Addendum Number Two

To The Drawings and Specifications for
St. Mark's Charter School Remodel – St. Mark's, Kansas
Renwick Unified School District # 267

Issued: October 23, 2008

HANNEY & ASSOCIATES ARCHITECTS

S7.2

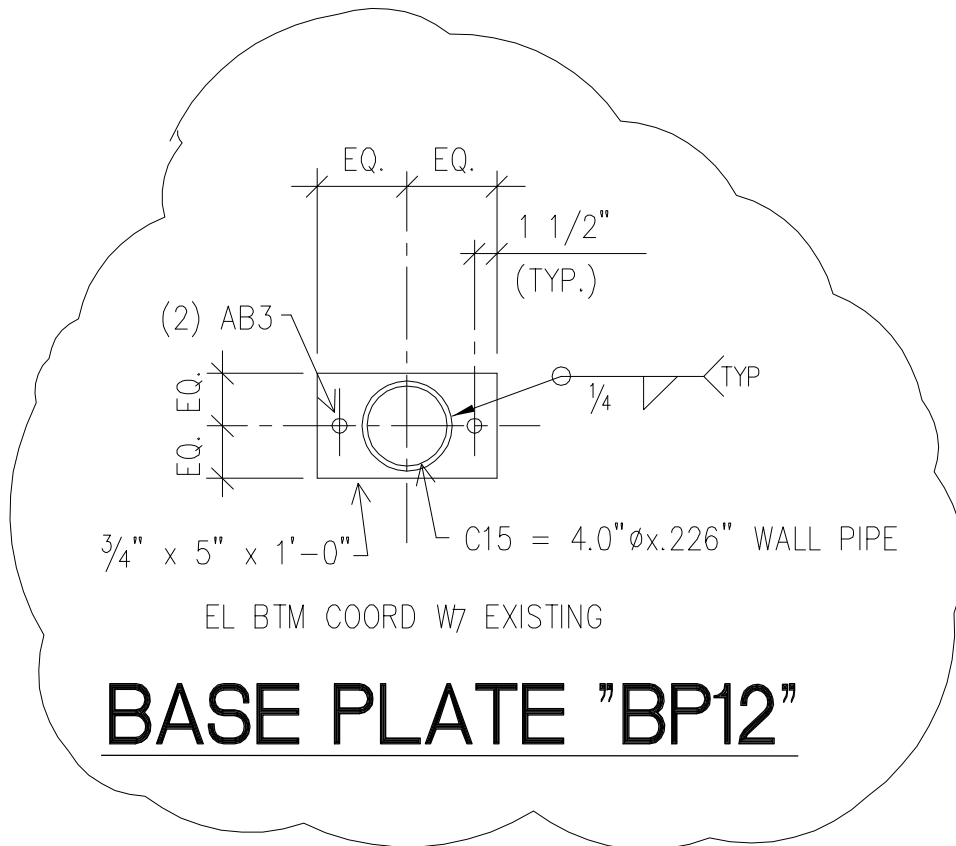
10/22/08 MECH'L RTU COORDINATION

C AREA "C" ROOF FRAMING PLAN

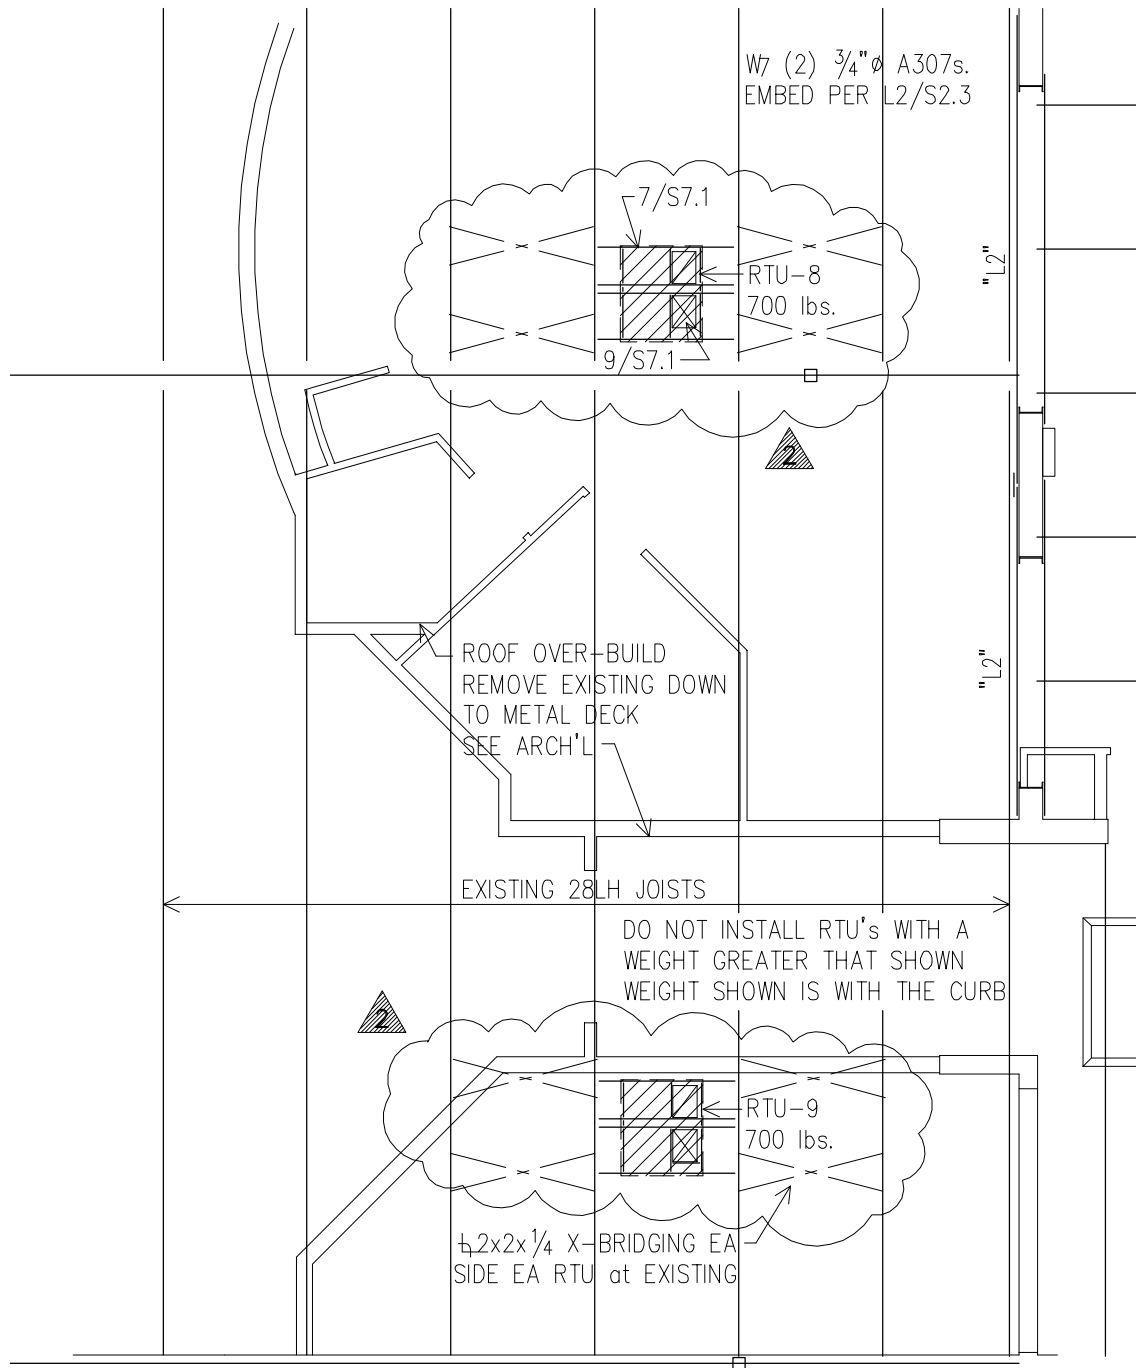
10/22/08	MECH'L RTU COORDINATION

D AREA "D" LOW ROOF FRAMING PLAN

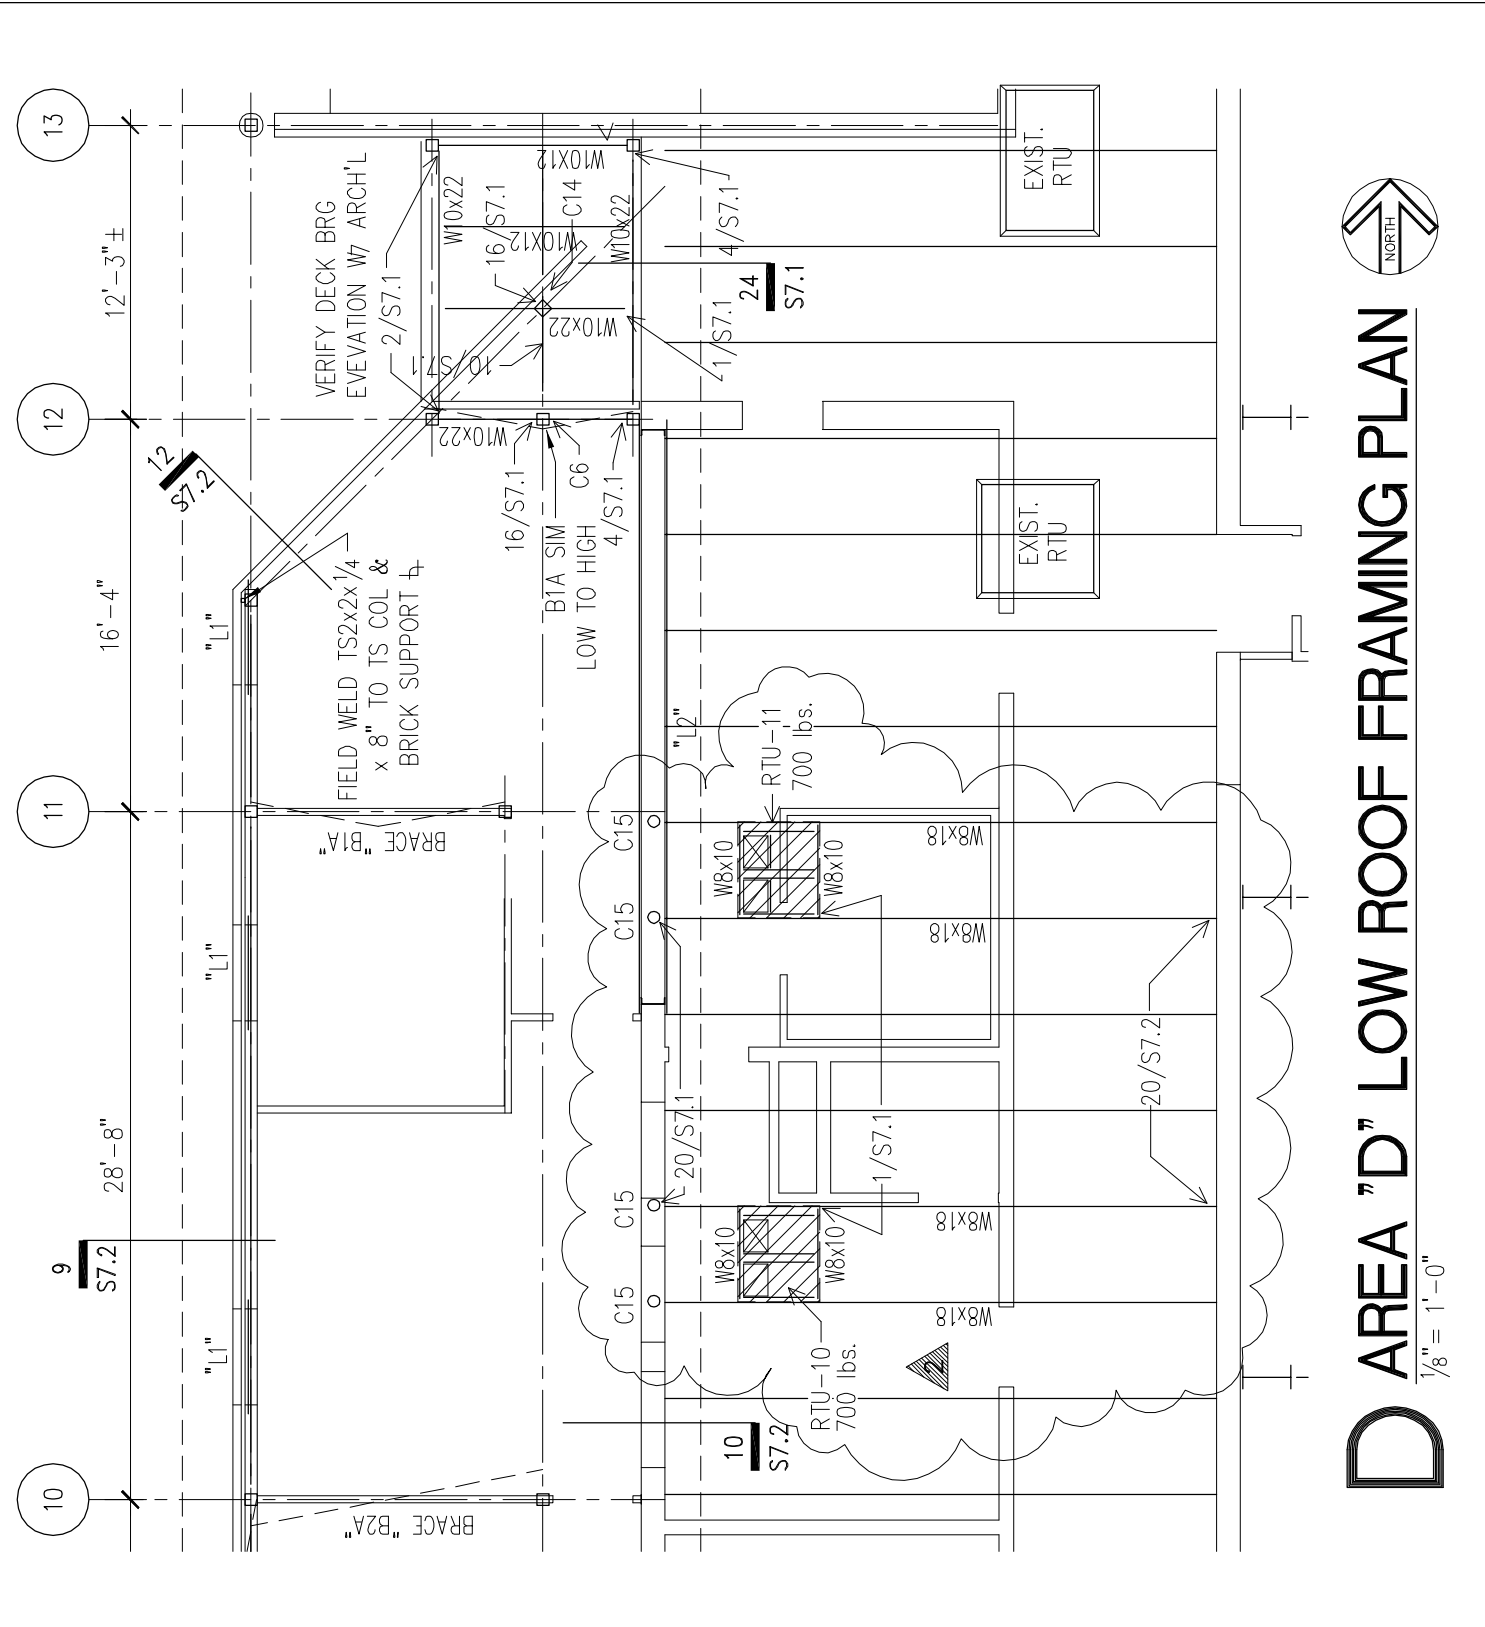
10/22/08 MECH'L RTU COORDINATION
